## SOUTH WEBER PLANNING COMMISSION AGENDA

To: Planning Commission  
From: Trevor Cahoon, Community Services Director; Brandon Jones, City Engineer  
Re: Public Hearing and Action on: Preliminary Plat (2 Lot Commercial Subdivision),  
Conditional Use & Architectural Site Plan Review for Crosswind Subdivision Parcels 13-  
039-0082 & 13-039-0083 approximately 5.57 acres located at approximately 7750 S  
2700 E by applicant: Genneva Blanchard of John W Hansen & Associates

To: Planning Commission  
From: Trevor Cahoon, Community Services Director; Brandon Jones, City Engineer  
Re: Public Hearing and Action on: Preliminary Plan, Rezone (from C-O to R-7), & Development Agreement for Deer Run Townhomes Parcel# 13-364-0001 2.914 acres located at 7897 S 2700 E for applicant: Joseph Cook of Deer Run Investments LLC.

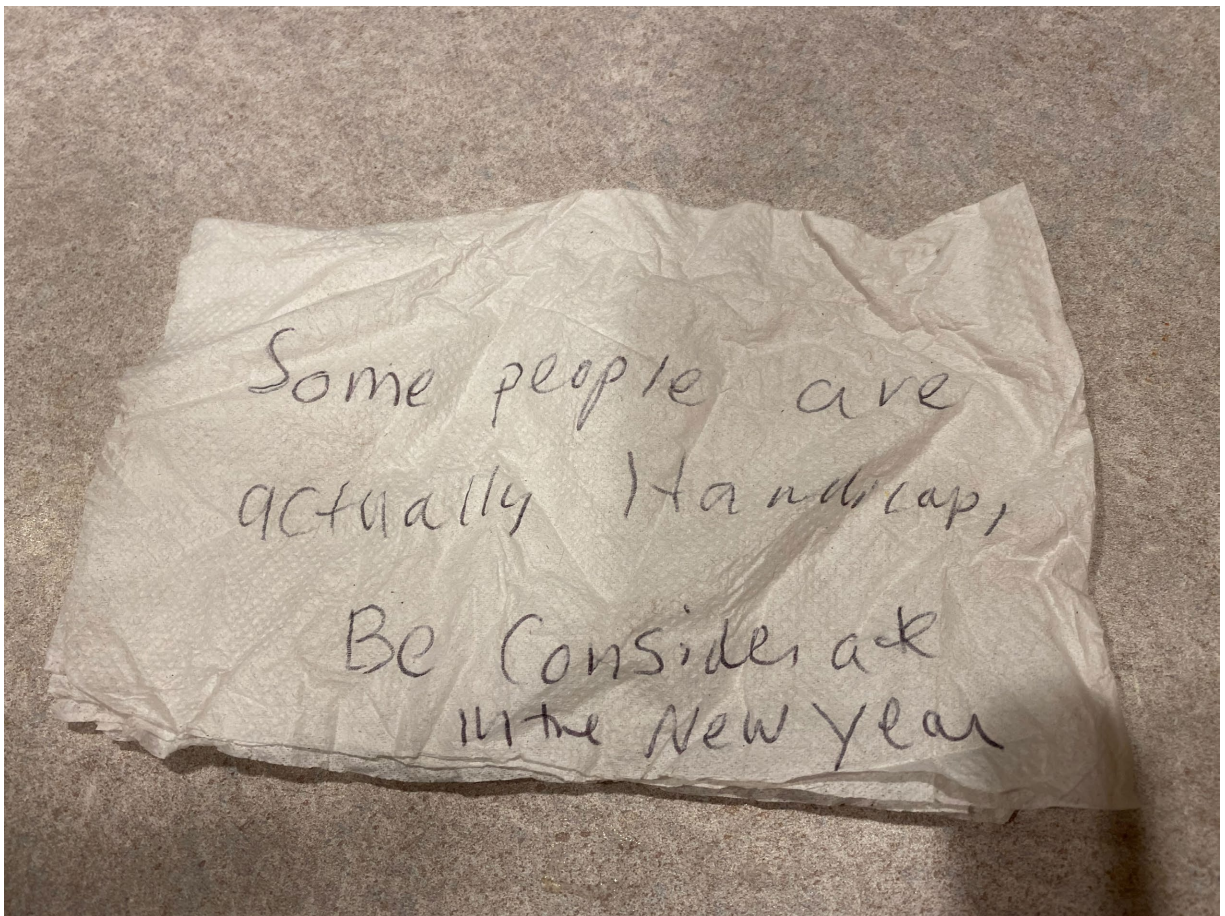
Can you tell this is a handicap parking space in front of the State Farm building? Last week, I was parked here and was left a sarcastic note on my door handle assuming I was not being considerate of handicapped people. It was dark and had been raining, just as it is tonight. Honestly, I did not see this was a handicapped parking space. And I am not the type of person who purposefully parks in handicap spaces. With that said, I noticed a problem with these handicap spaces: when it is dark/raining or snowing, there is no way to tell these spots are designated for handicapped. Unlike the last two pictures I posted, there are no posted visible signs for days like today, when the weather inhibits a person's view. I don't know who needs to see this, but the city, or building manager or Jay Carnahan/State Farm need to install posted handicap signs for all weather. Hoping this can make some changes and help those who need the use of those handicapped parking spaces.

**C400**  
SITE PLAN

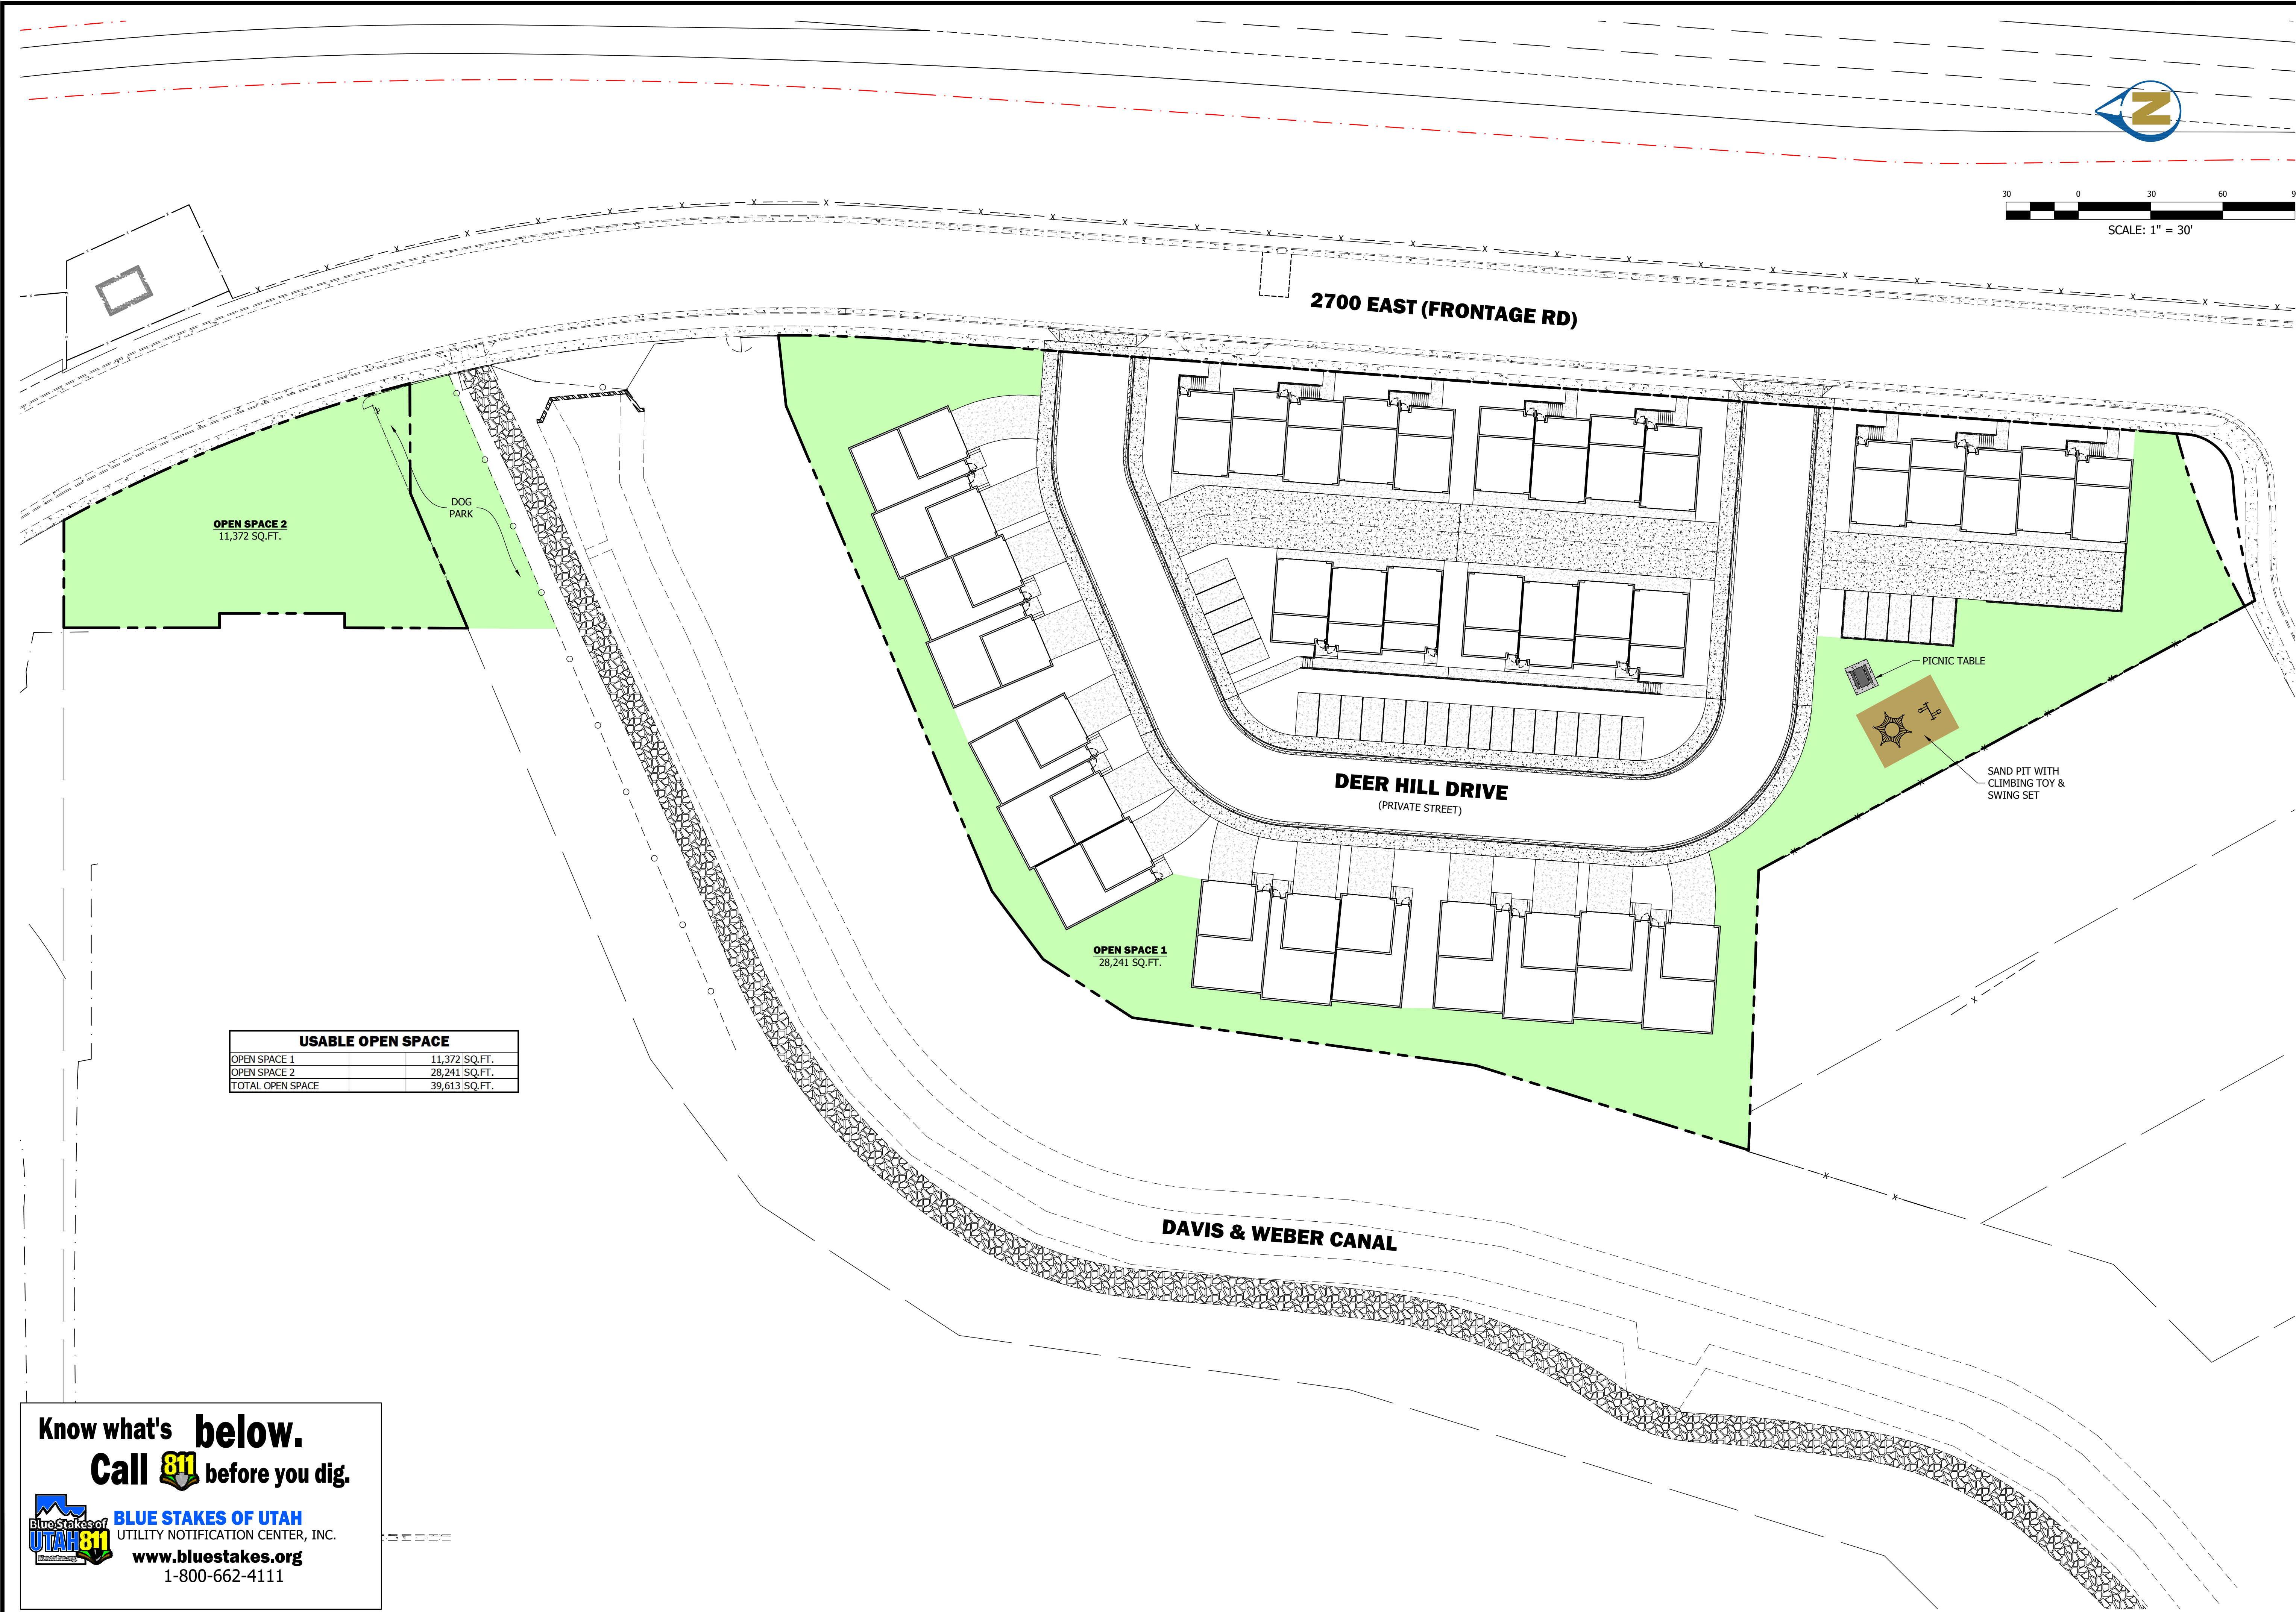
From the Development Agreement: Open space shall be accessible to the residents of the Development and configured in a manner to promote outdoor leisure. **The OpenSpace Calculations on the plans need to be updated to reflect the correct open space designations.** The development requires 19,000 square feet of open space. The total open space that is within main project area is sufficient for the development.

- E6. Road Dedication. There is a space piece of ground on the northwest corner of the Deer Run Dr / 2700 East intersection that is shown as being dedicated to the road. We need some explanation as to why this is being proposed.
- E7. Missing parcel. The open space parcel (Parcel A) appears to have an additional parcel immediately adjacent to the south that is not being included. This should be included.
- E8. Property/Ownership Table. The preliminary plat needs to be updated to show the proposed ownership of the property correctly. For example, the private road is being shown as open space, but should be shown as Limited Common. Please review all areas and update accordingly.
- E9. Addresses. Addresses for the lots will be provided by our office with the next review.
